V2 - SDP-23-02 - Response to Planning Elevations comments only.

PROJECT: RETAIL SHOPS
6000 ROGERS ROAD
ROLESVILLE, NC 27571
DRAWING: EXTERIOR ELEVATIONS

1 FRONT (EAST) ELEVATION
A201 SCALE: 3/16" = 1'-0"

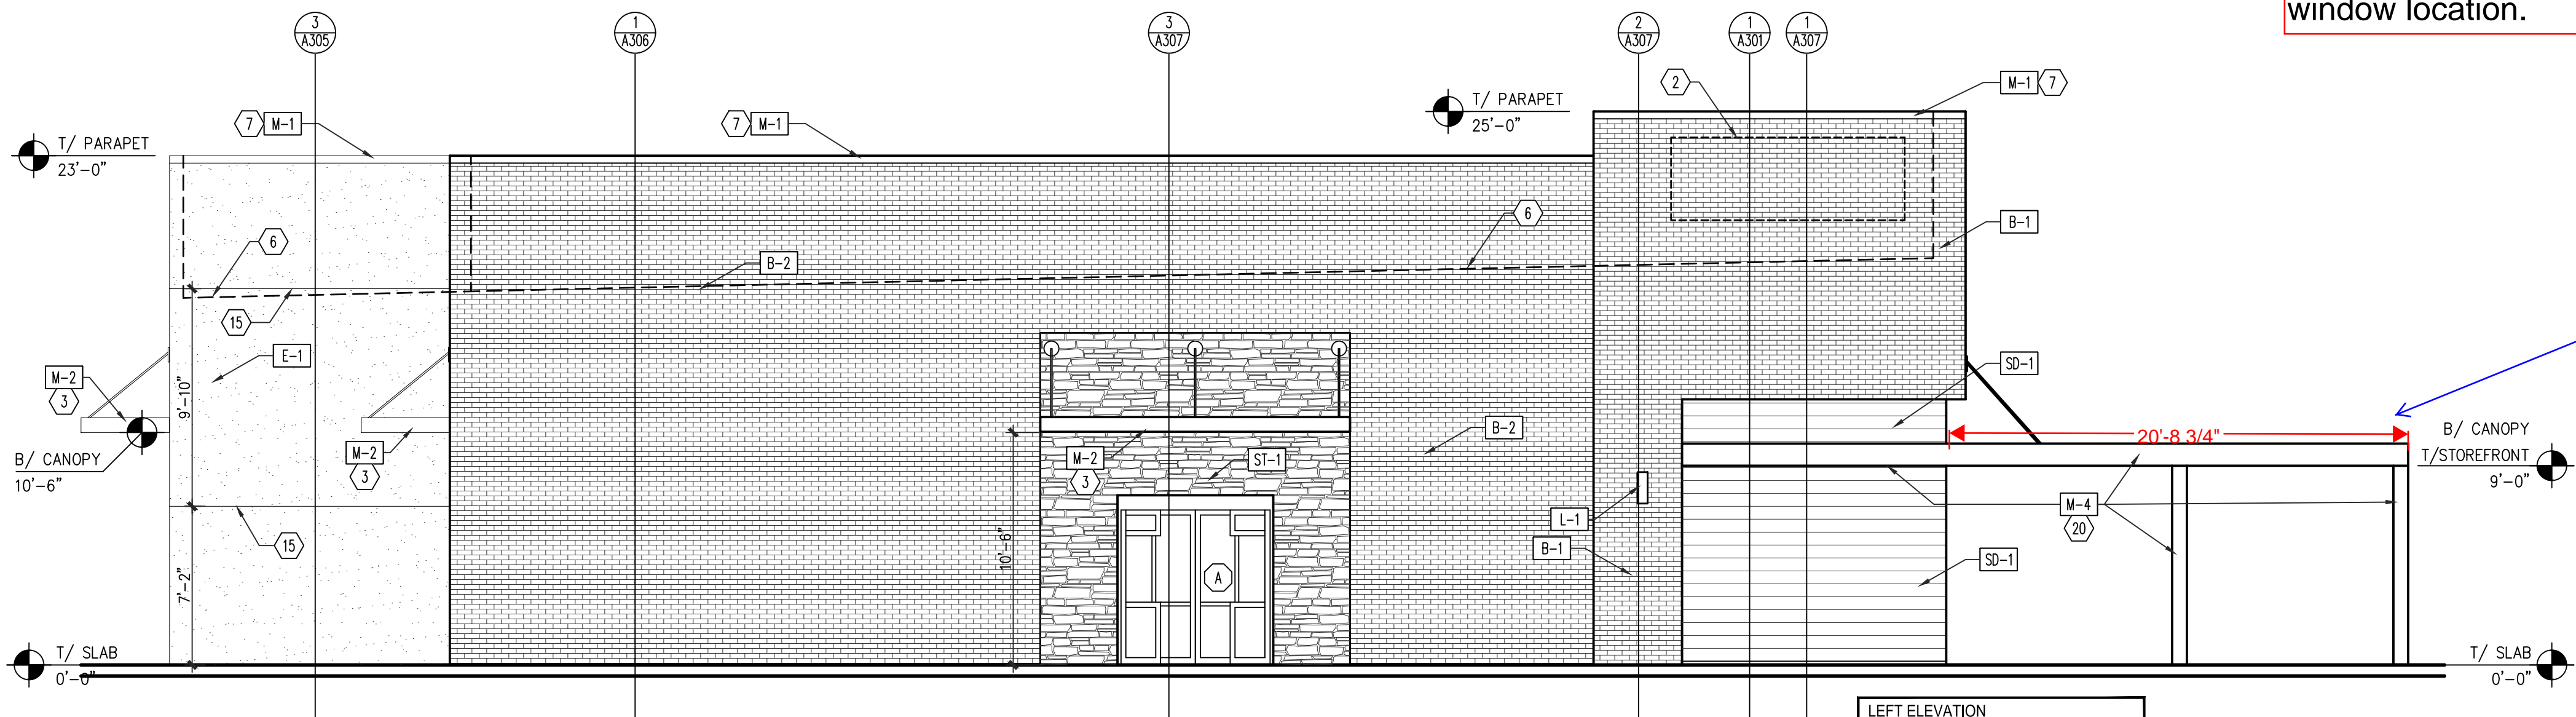
COMMENT 40 - Clarify canopy location and intention. On the site plan sheet, please note the canopy location. Is this meant for outdoor seating? Or to cover the drive through?

COMMENT 42 - Edit to be compliant with language used in the LDO. The Town does not have minimum glazing requirements. Per LDO Section 6.8.2.C, mirror window glazing is a prohibited building design element. Each building does have a transparency requirement as noted in LDO Section 6.8.2.D.2

Transparency requirements note has been updated per LDO requirements on the right (north) Elevation and front (east) elevation.

Notes have been added to drawing A201- intention of canopy to be a covered exterior seating area.

2 LEFT (SOUTH) ELEVATION
A201 SCALE: 3/16" = 1'-0"

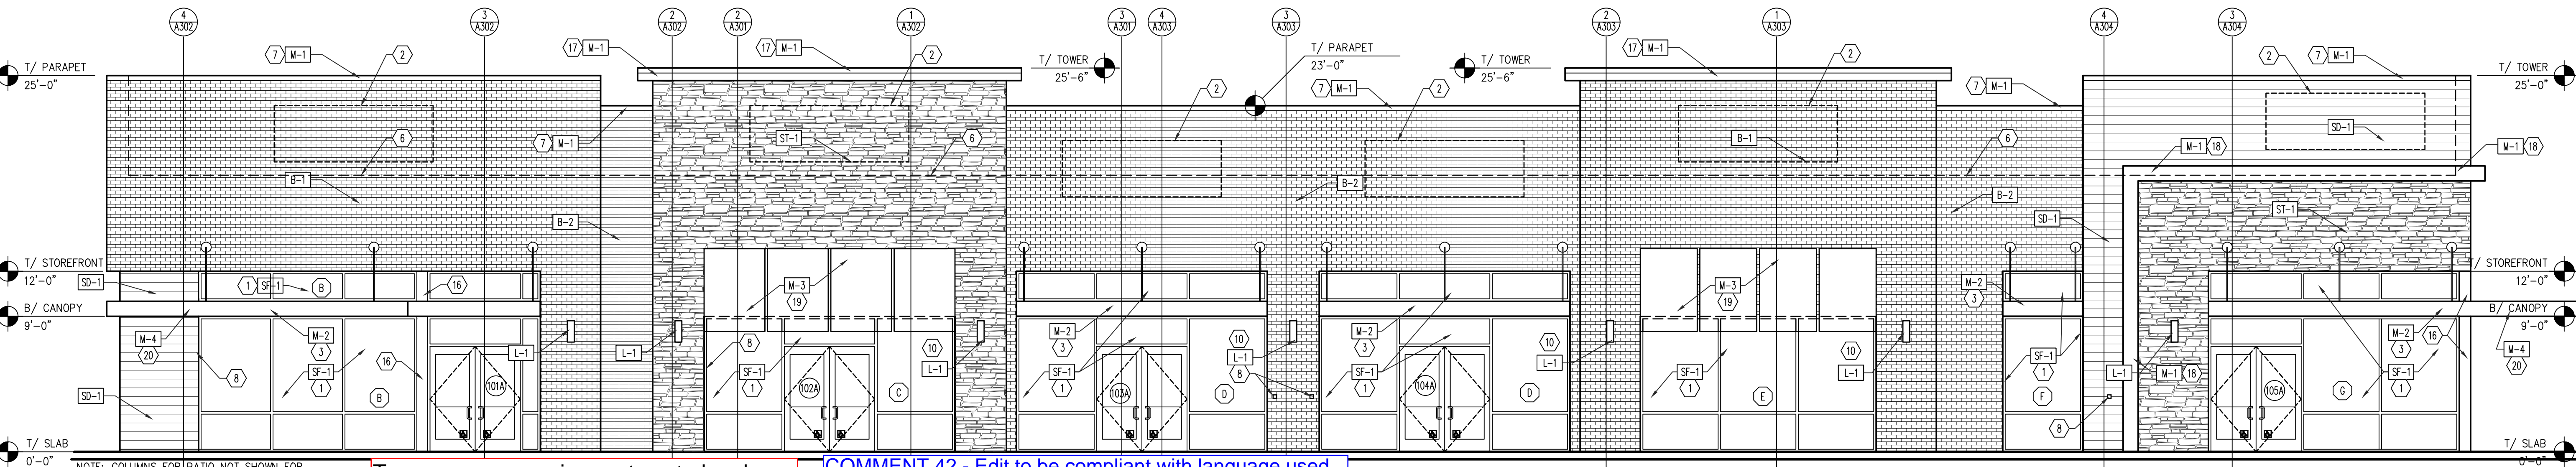
COMMENT 38 - Facades of 60 or greater feet in width shall incorporate wall offsets of at least one (1) foot of depth a minimum of every forty (40) feet. Illustrated as "D" in Figure 6.8.1

COMMENT 39 - Facades greater than one-hundred (100) feet in length shall require a repeating, consistent pattern of change in color, texture, and material according to LDO Section 6.8.2.D.1.e.

COMMENT 41 - Label the location of the drive-through window on the building.

All elevations now meet requirement, left elevation has been revised to include a 1'-0" wall offset at the drive thru window.

All elevations now meet requirement, left elevation has been revised to include a 1'-0" wall offset with stone veneer at the drive thru window location.

Notes have been added to drawing A201- drive thru window location has been labeled.

2 RIGHT (NORTH) ELEVATION
SCALE: 3/16" = 1'-0"

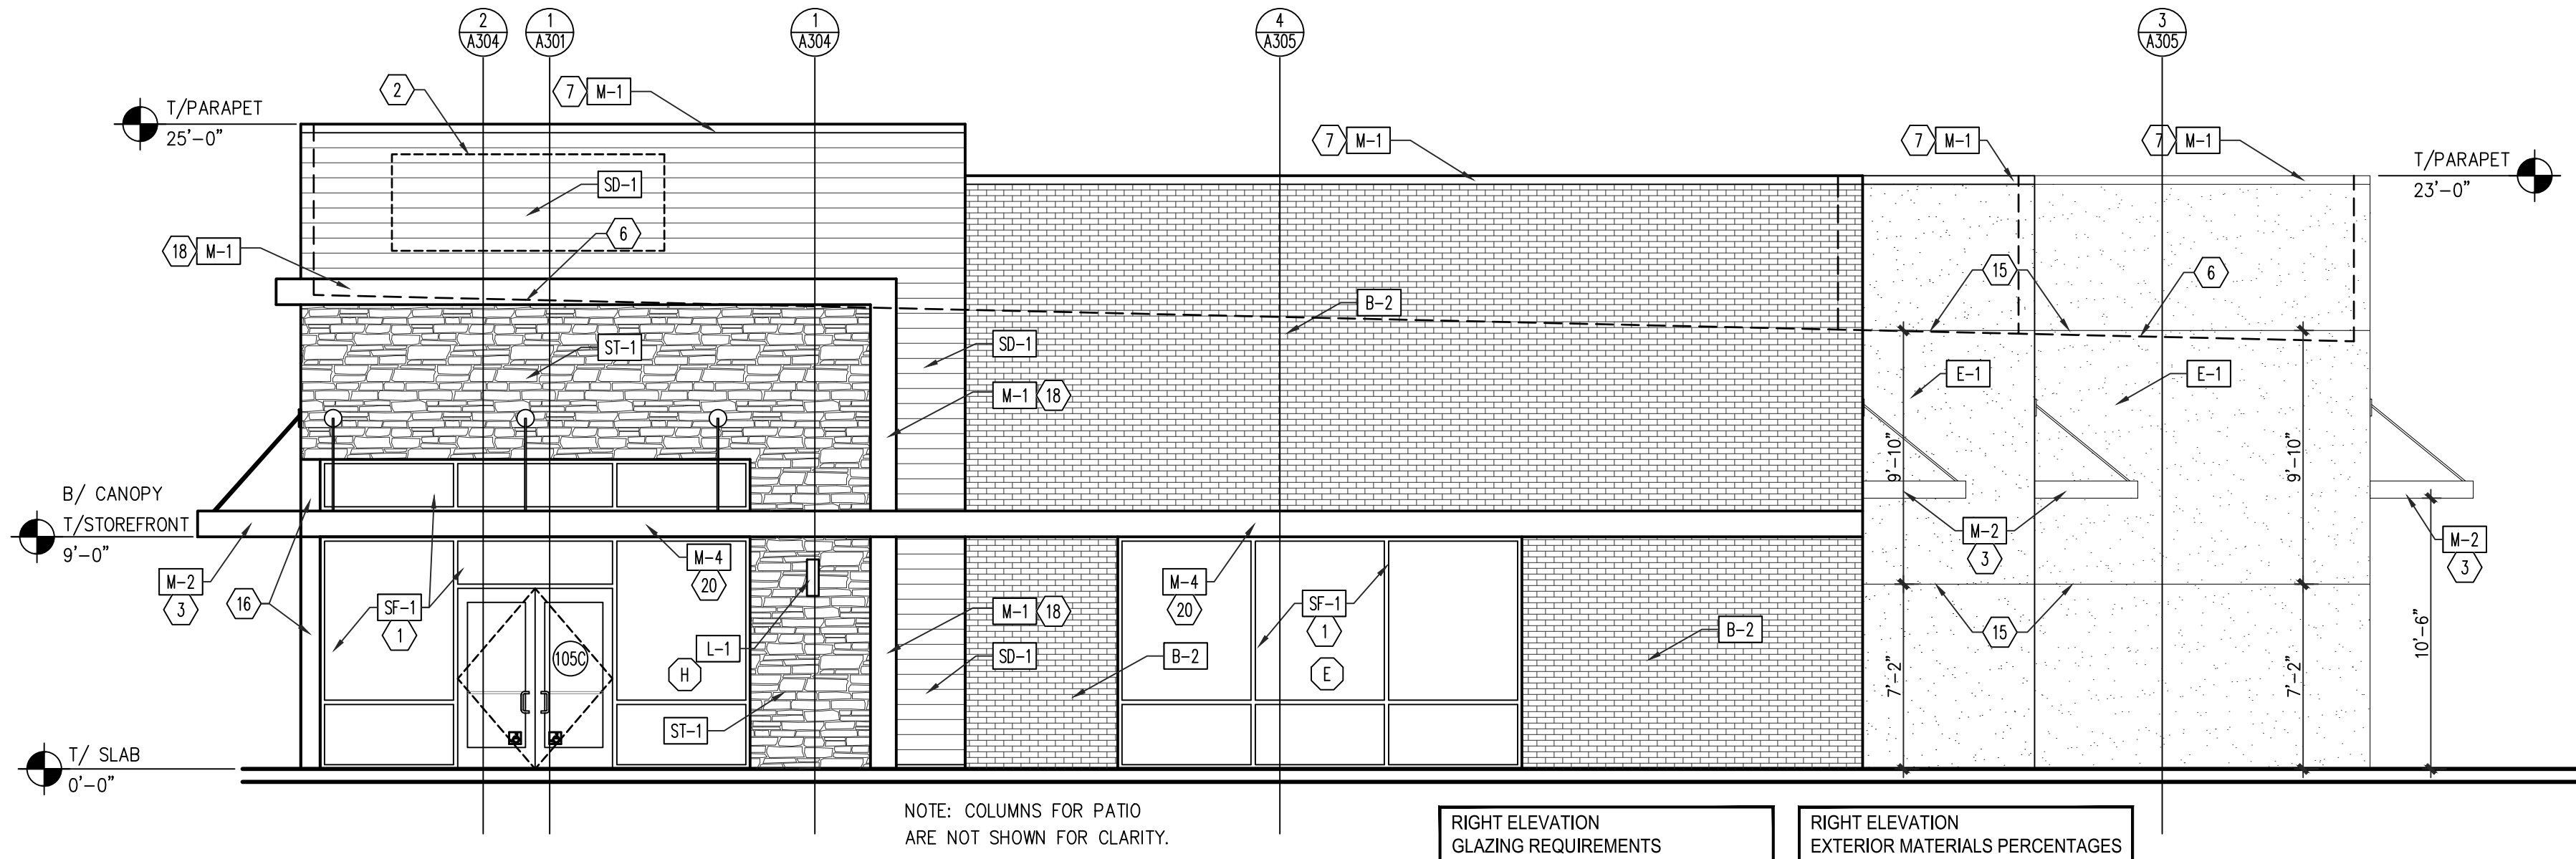
COMMENT 45 - Label the location of the drive-through window on the building.

COMMENT 46 - Edit to be compliant with language used in the LDO. The Town does not have minimum glazing requirements. Per LDO Section 6.8.2.C, mirror window glazing is a prohibited building design element. Each building does have a transparency requirement as noted in LDO Section 6.8.2.D.2

Notes have been added to drawing A201- drive thru window location has been labeled. There is not a drive thru window on the right (north) elevation.

Transparency requirements note has been updated per LDO requirements on the right (north) Elevation and front (east) elevation.

1 REAR (WEST) ELEVATION
SCALE: 3/16" = 1'-0"

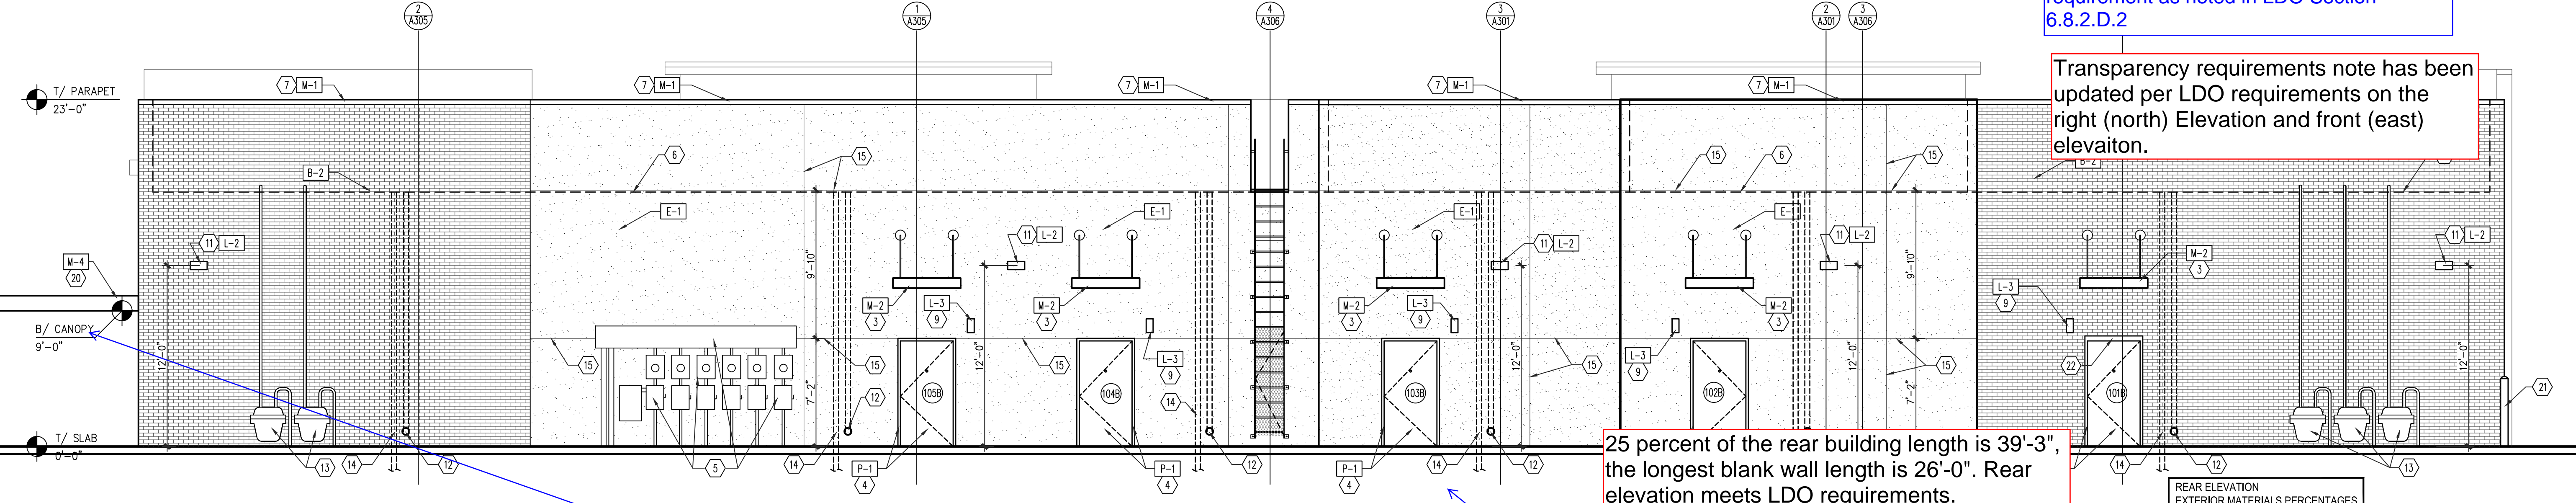
COMMENT 43 - Reconfigure sheet to be able to show the full length of the canopy as it is cut off here.

COMMENT 44 - Except as otherwise regulated, the maximum permitted blank wall length for the rear of buildings shall be one-hundred (100) feet, or twenty-five (25) percent of the building length, whichever is less.

For rear elevation on drawing A202, notes have been added to show the length of the canopy.
